## ALPINE CITY PLANNING COMMISSION MEETING

#### A. PUBLIC HEARING – Beck Zone Change Request

#### B. Eagle Pointe PRD Final Plan - Mark Wells and Taylor Smith - Approx. 800 W 600 N

**SUBJECT: Eagle Pointe PRD Final Site Plan**

Eagle Pointe Subdivision 1000 Hollow Rd/Waterford Dr. Alpine City, Utah 84003		Scale: 1"=40' Date: 07/02/15 Drawn by: [Name] Checked by: [Name]
EXCHL ENGINEERING 12500 W. 2000 S., Suite 201, Provo, UT 84603 Phone: 801-726-4511		WALL PROFILE COMPARISON 1 OF 1

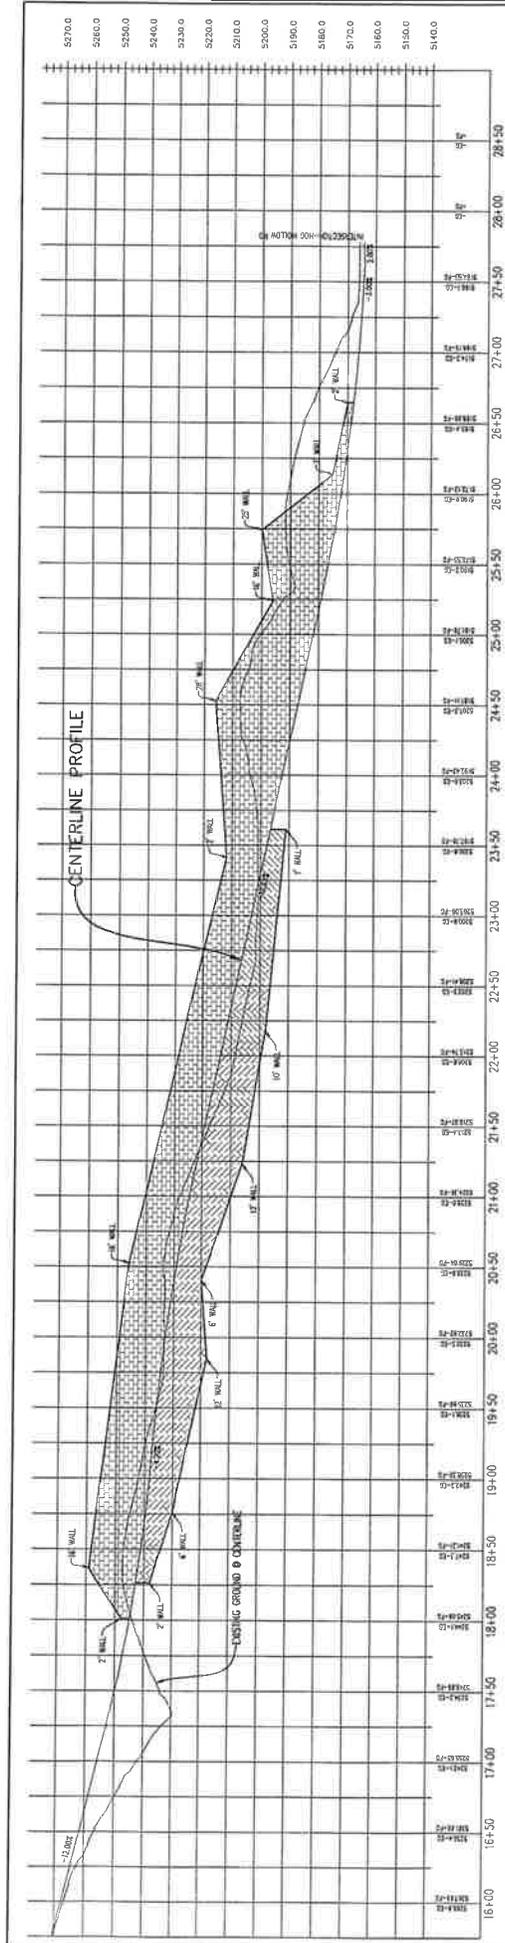
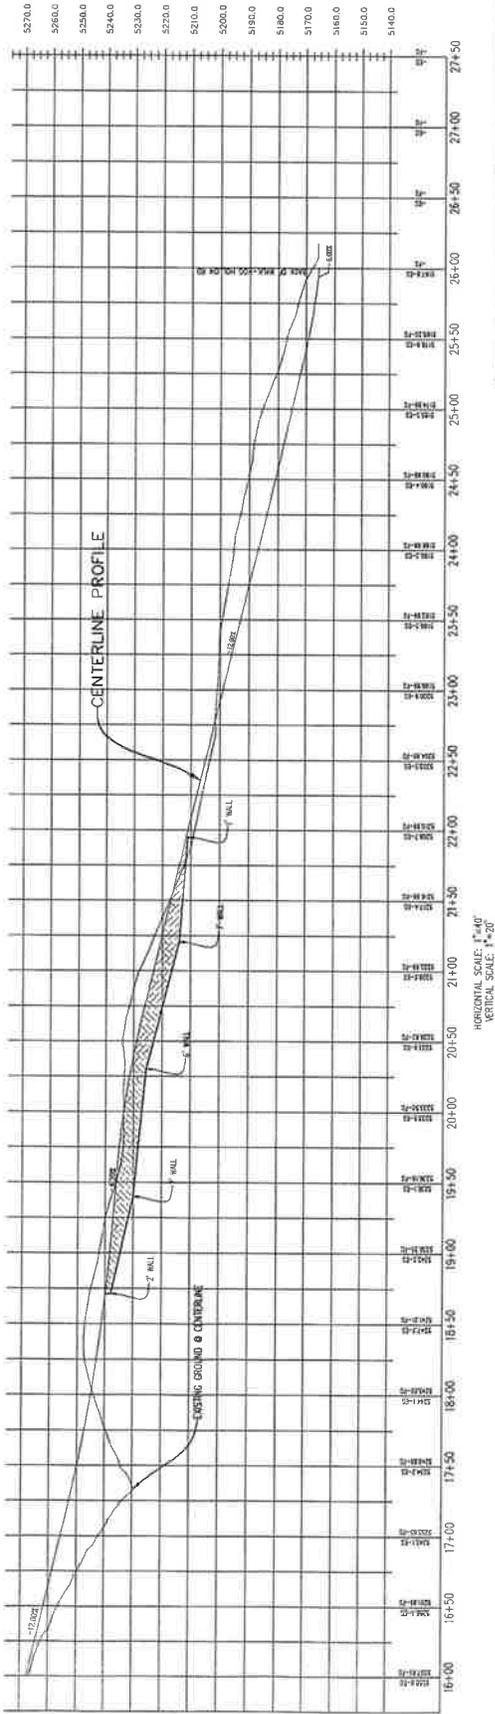
Please refer to the drawing "Wall Comparison Profile" which illustrates the drastic reduction in retaining walls. The entire upper retaining wall portion is eliminated and the lower retaining wall portion is reduced to a maximum of seven feet in height along a much shorter length.

**a-3**

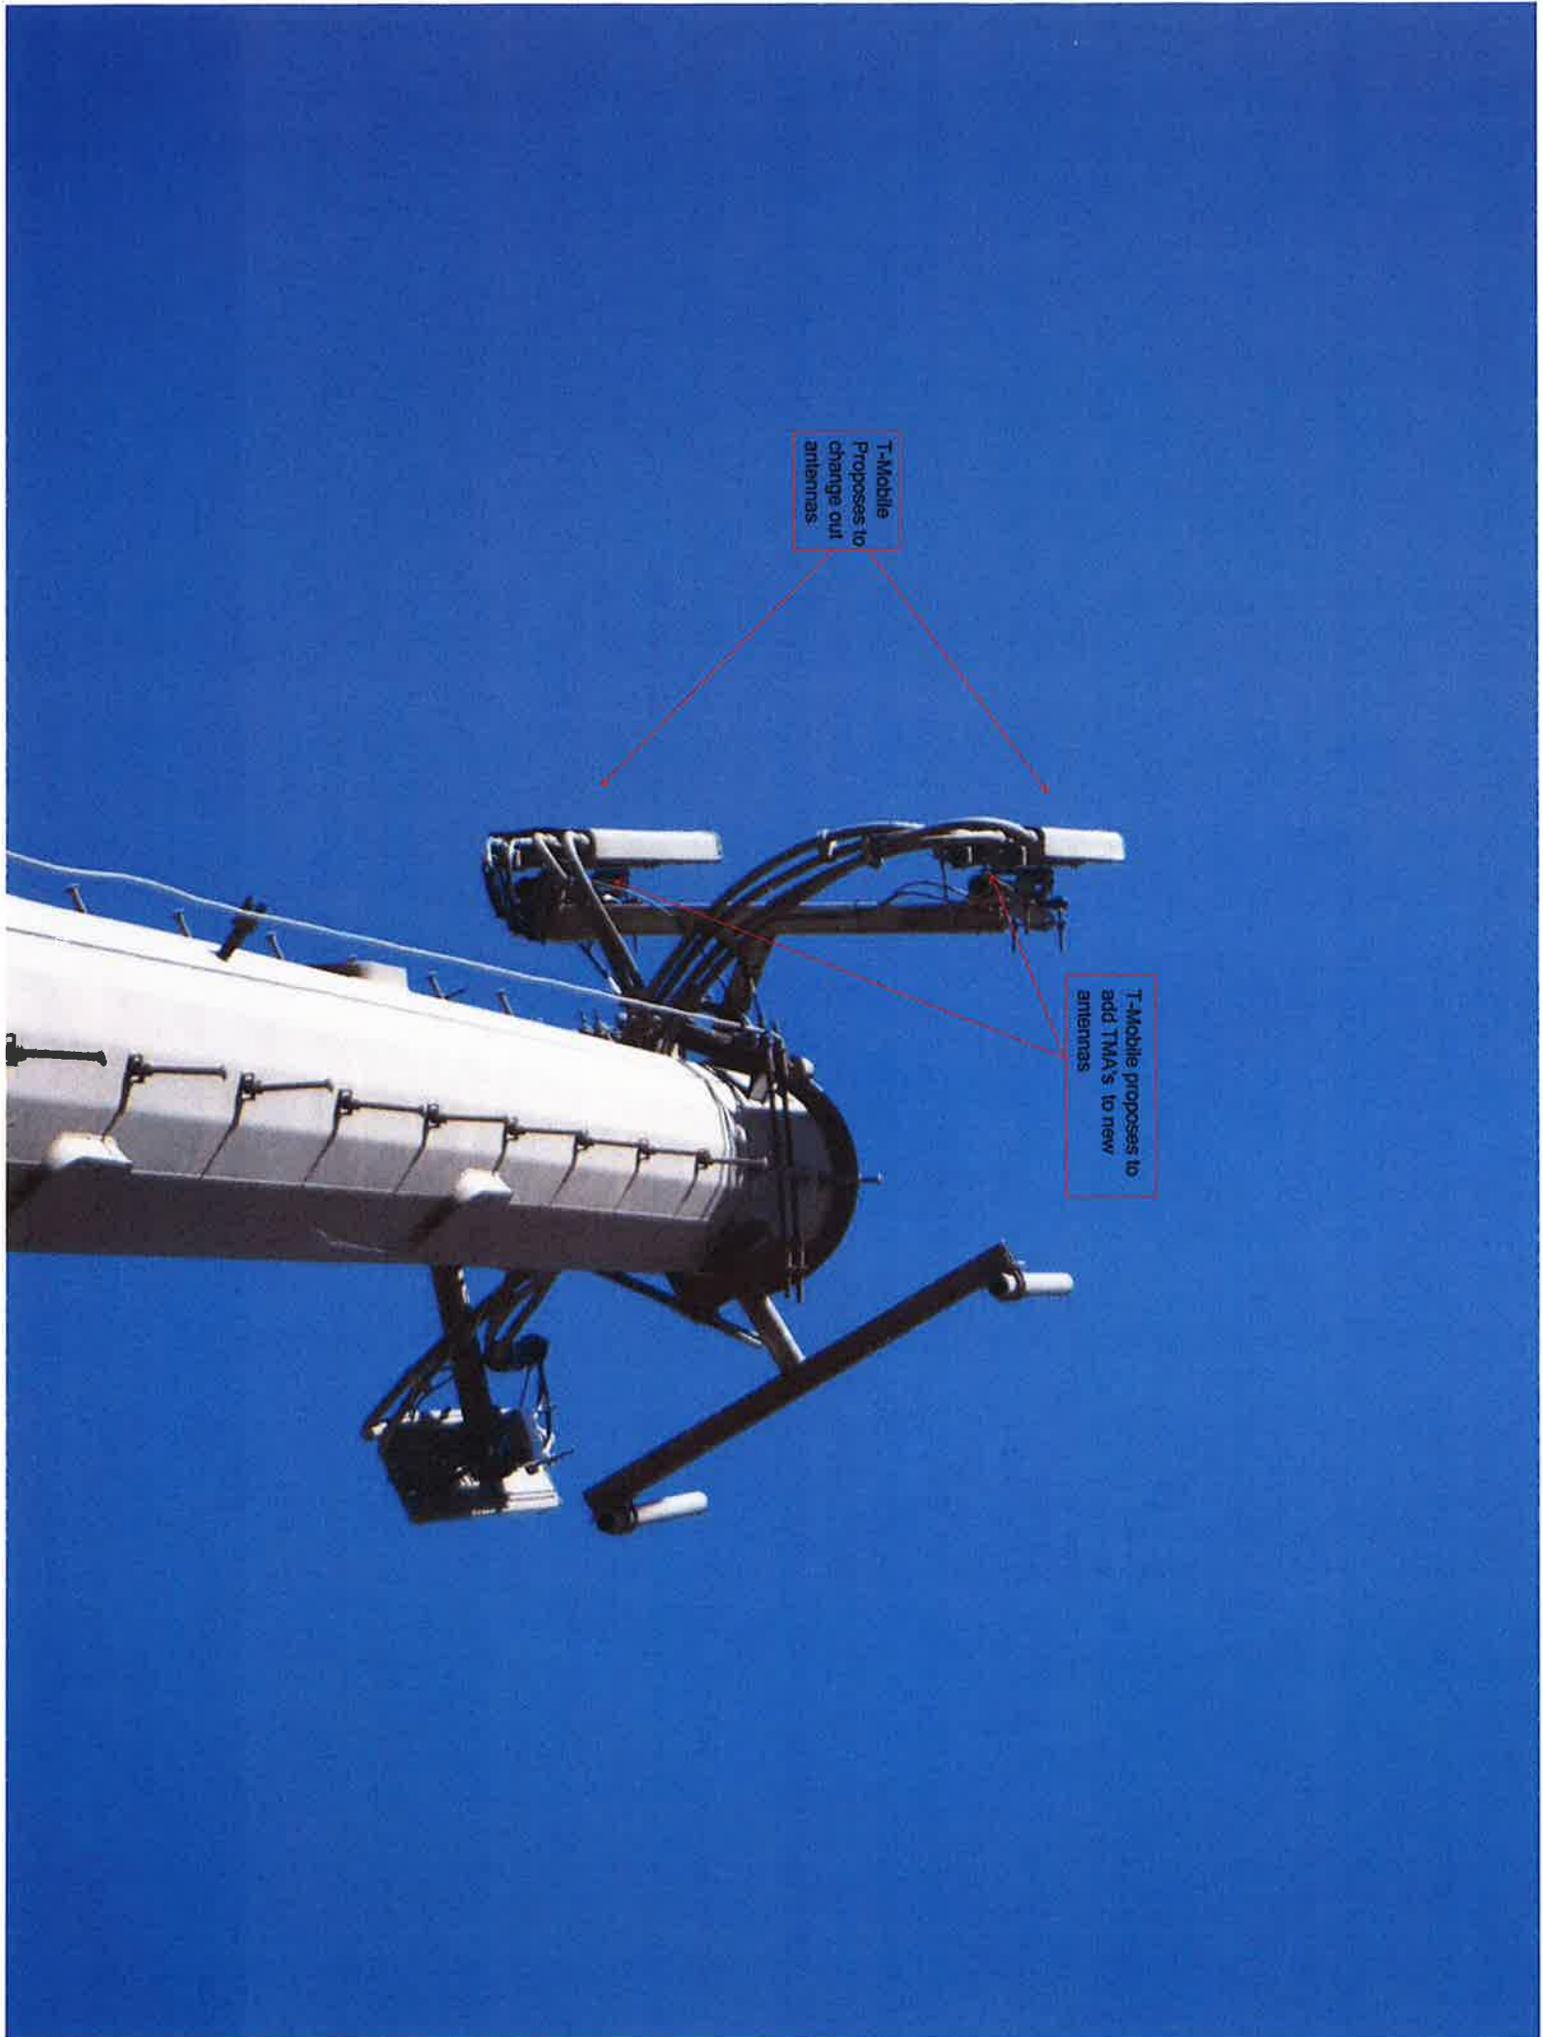
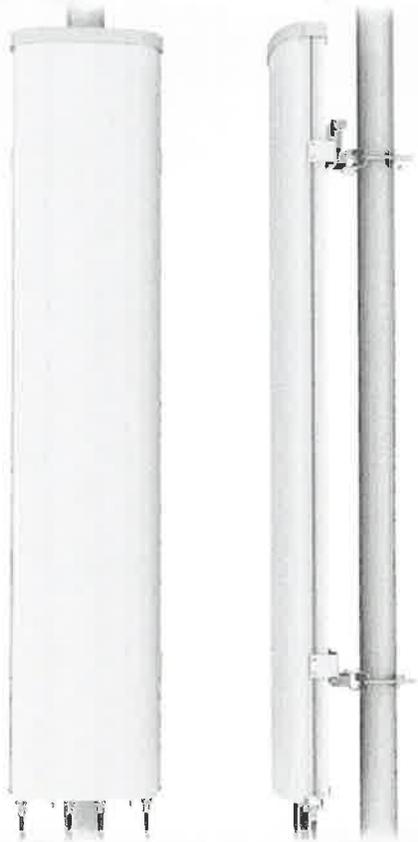
T-Mobile  
Proposes to  
change out  
antennas.

T-Mobile proposes to  
add TMAs to new  
antennas

T-Mobile proposes to change antennas
